Illustrated Parts List - IPL Update

LEGACY SNOW THROWERS ORIGINALLY EQUIPPED WITH 532188170

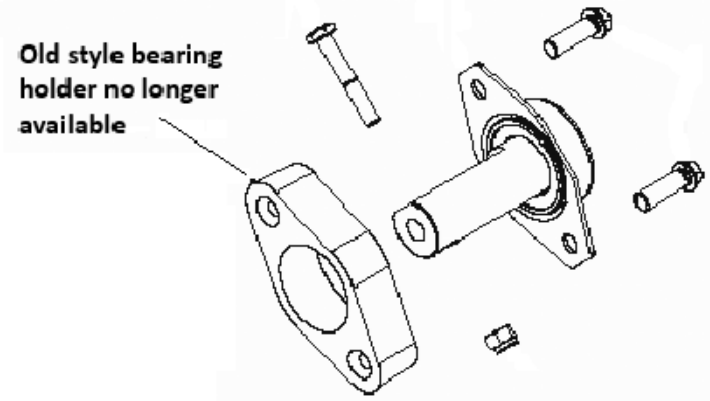
The old design Bearing Holder is no longer available. Where replacement is required, machines can be updated to the new design as shown below. For each side requiring repair, please order the following:

Retrofit does not require both sides be updated (one side can remain "old style" while the other is updated).

1: 532420478 Bearing holder - Quantity 1
2: 532411939 Cap - Quantity 1
3: 584299401 Screw - Quantity 2
